Redaction in the 2011 NASA Report 'NHTSA Toyota Unintended Acceleration Investigation'

Prepared by Dr A F Anderson CEng FIEE

February 10th 2011

Fig 3 Page 84 Part of Figure 6.6.1 – Section 2.4 Power Error portion of Ishikawa or fishbone Diagram for Postulated causes of Uncommanded Acceleration

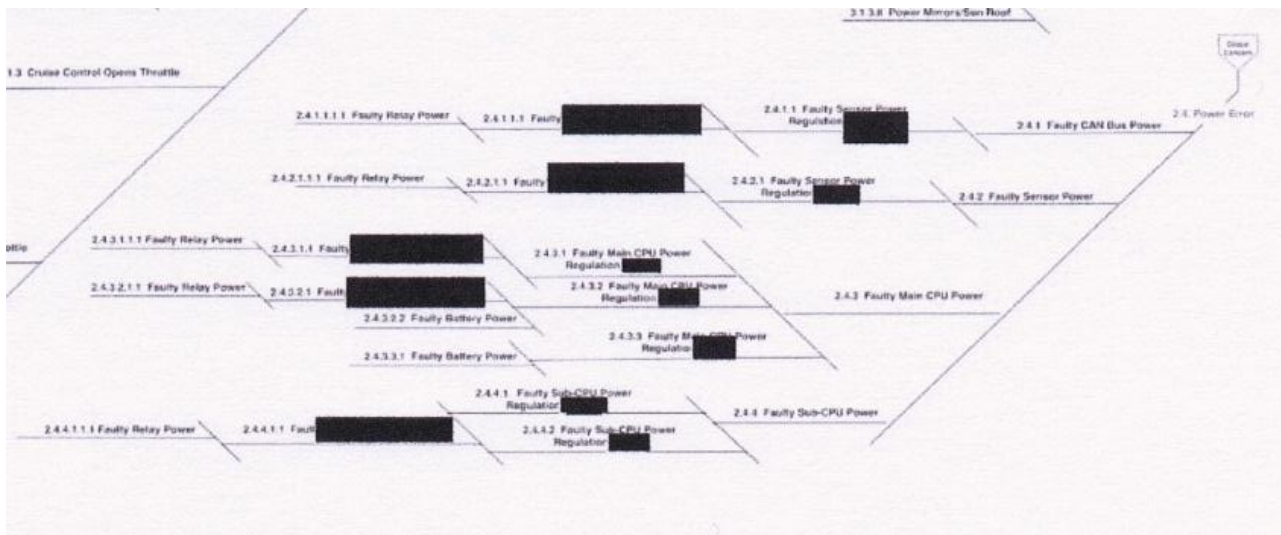
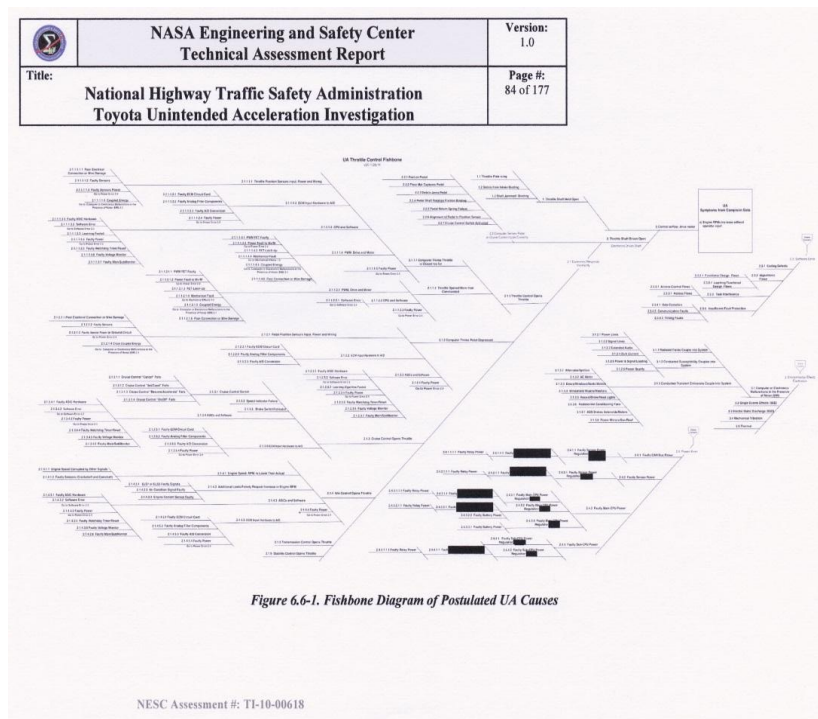
Why should anyone want to hide the power error portion of a diagram that relates cause and effect? Surely, was not the object of the whole investigation to identify possible causes of sudden acceleration and prove or disprove them? Here some of the possible causes of sudden acceleration and their interactions are being **hidden** from public view. This looks like a case of trying to put the cat back into the bag.

Fig 5 Page 87

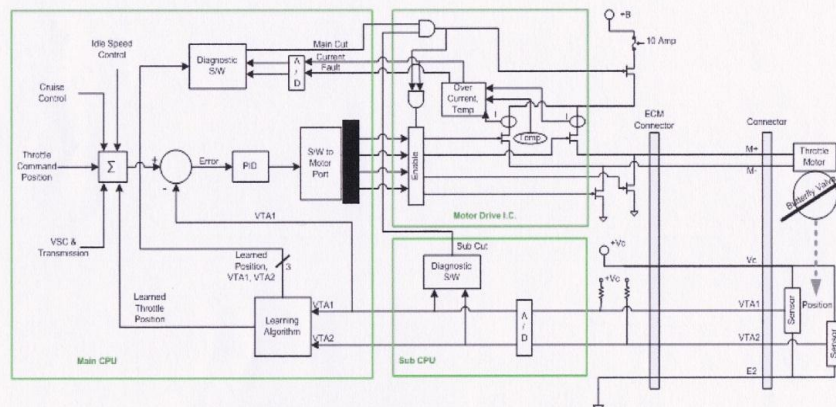
NASA presumably wanted to explain how the electronic throttle system worked, but NHTSA seems to have decided, for reasons best known to itself, to hide that information. Why is it necessary to hide the way the throttle system works?

Fig 8 Page 139 Relates to ECM Power System

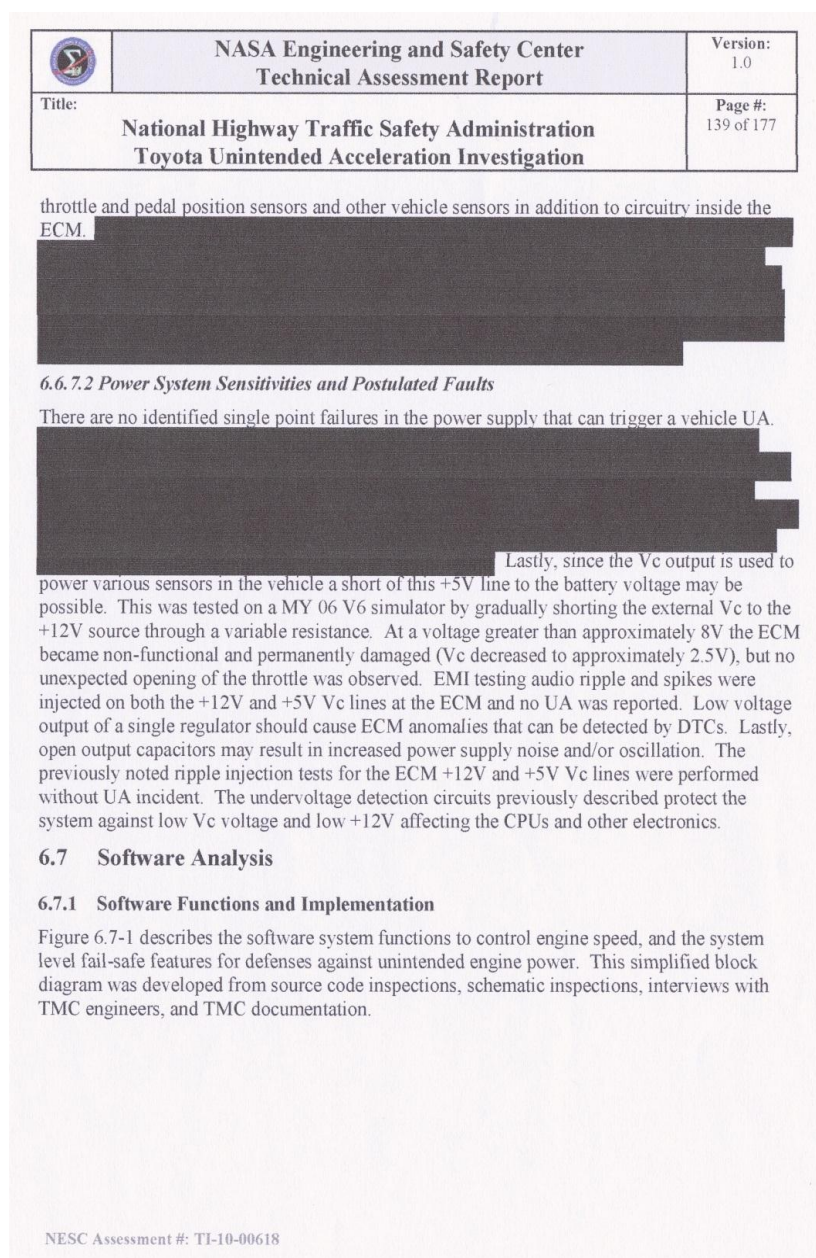
Why is it necessary to blank out information relating to the power supply to the pedal position sensors and other vehicle sensors? See also fishbone diagram Fig 3.

Why is it necessary to block out information about Power System sensitivities and postulated faults?

It has come to a pretty pass when information about postulated faults is blacked out! We don't want you to know about what NASA considered might be possible faults. Surely the opposite ought to be the case, i.e. you tell everyone exactly what postulated faults you have considered!
